NEWINGTON – 2018

SITE: WHITE TAIL RIDGE PH.3

CIVIC ADDRESS:
332 ANTLER COURT

Plans Review

Sheet Title DECK CONNECTION 4'-0"x8'-0"	
Drawn By DS	Checked By -
Project No.	Scale N.T.S.
Date DECEMBER 2019	Drawing No. 264

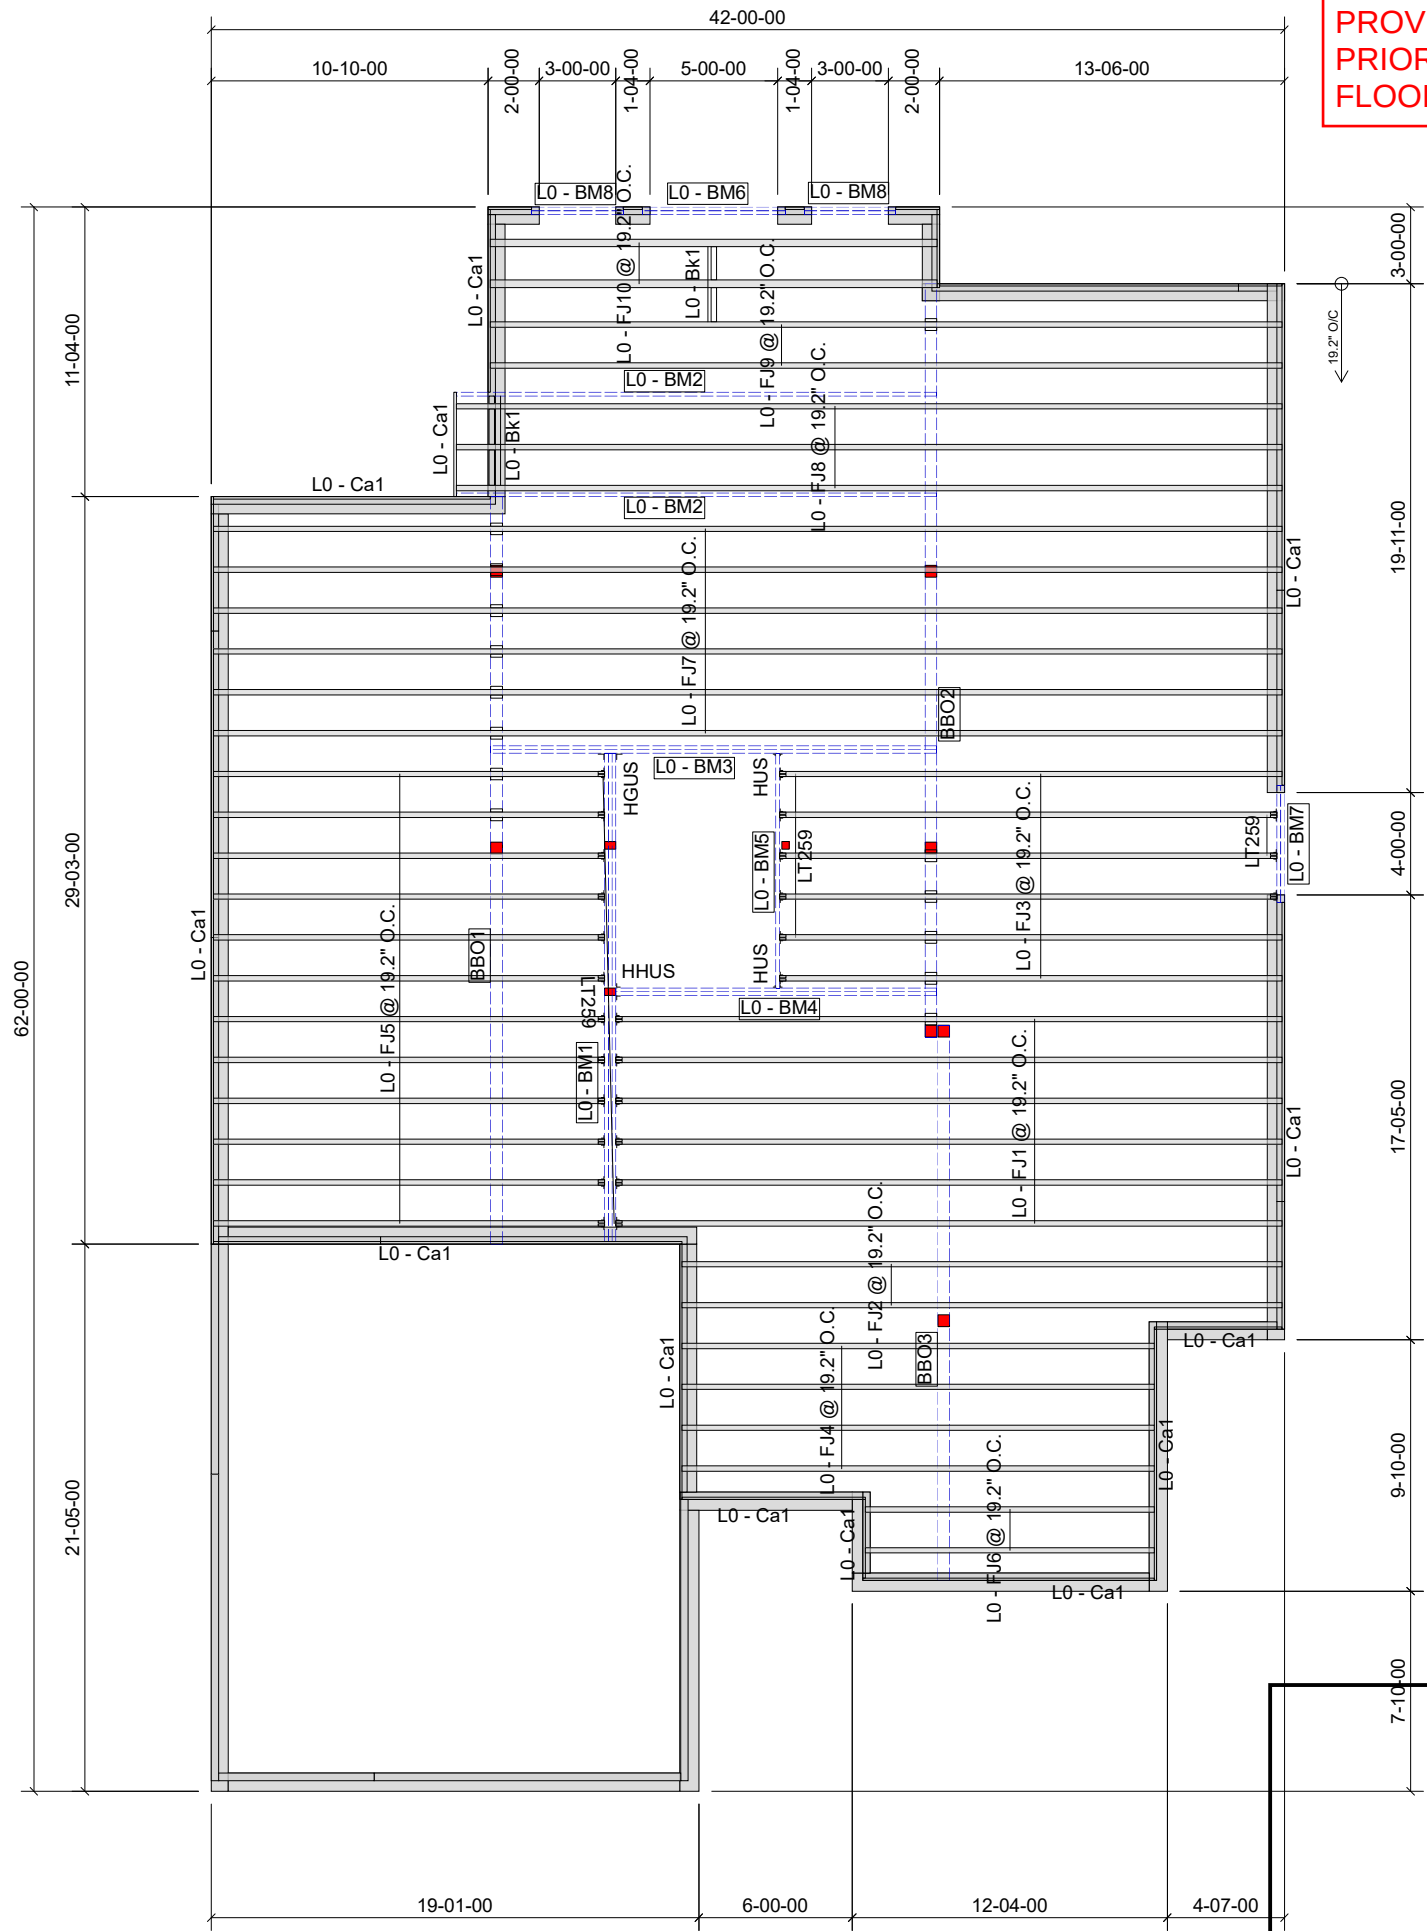
PROVIDE A COMPLETE PACKAGE OF SEALED TRUSS AND FLOOR PLANS PRIOR TO THE FRAMING INSPECTION. WIHTOUT THE STAMPED TRUSS AND FLOOR DRAWINGS, THE FRAMING INSPECTION WILL NOT BE CONDUCTED

JOB:
PHOENIX HOMES
WHITE TAIL RIDGE
WTR3-58
NEWINGTON A
1ST FLOOR 1 OF 2

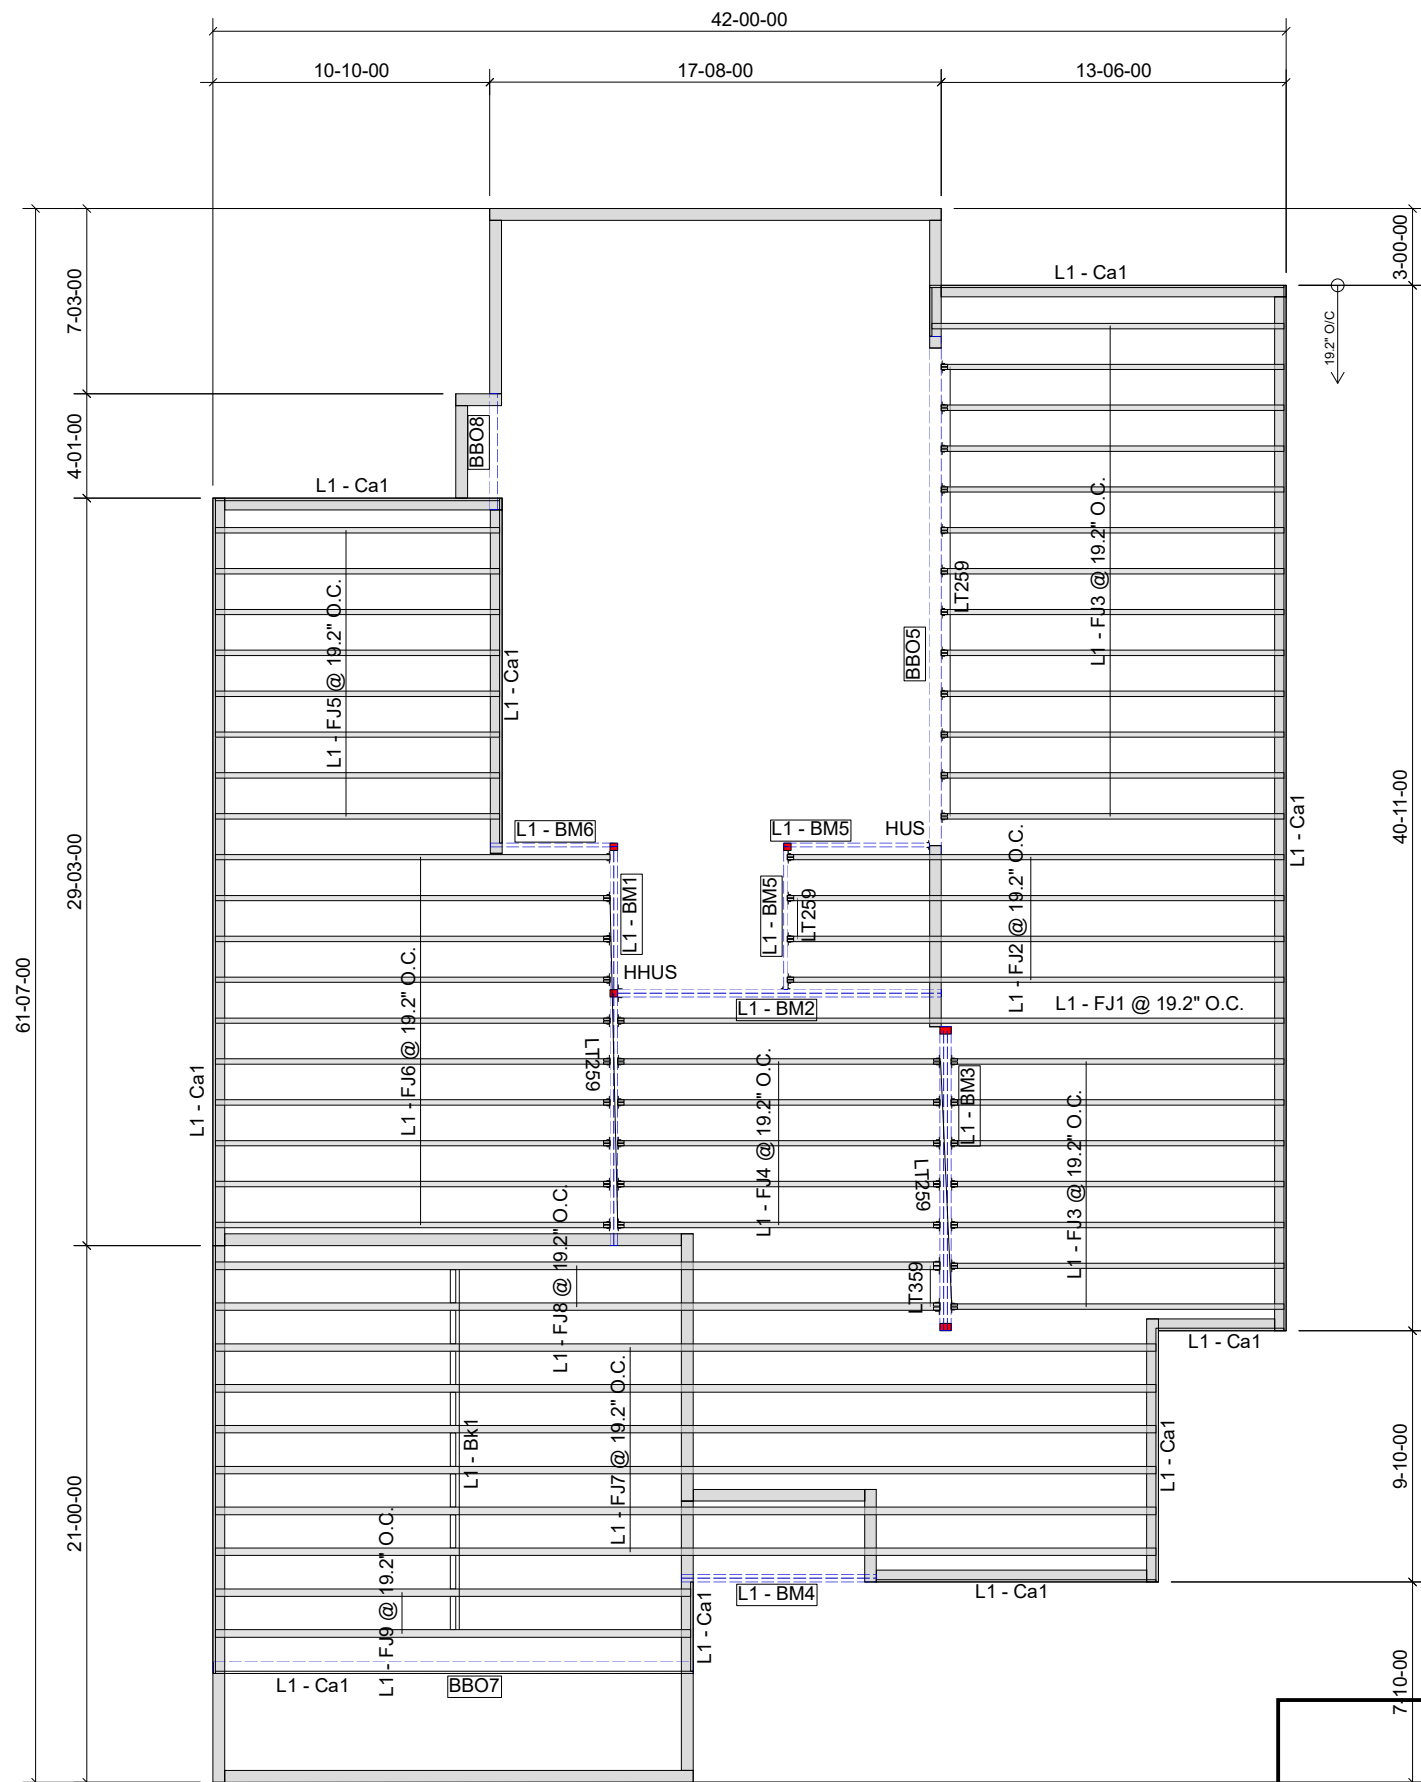
DETAILS SEALED BY A P.ENG ARE REQUIRED FOR THE LVL BEAMS ON FRAMING INSPECTION

PROVIDE P.ENG APPROVED FLOOR DRAWINGS AND SPECIFICATIONS TO BUILDING INSPECTOR AT FRAMING INSPECTION
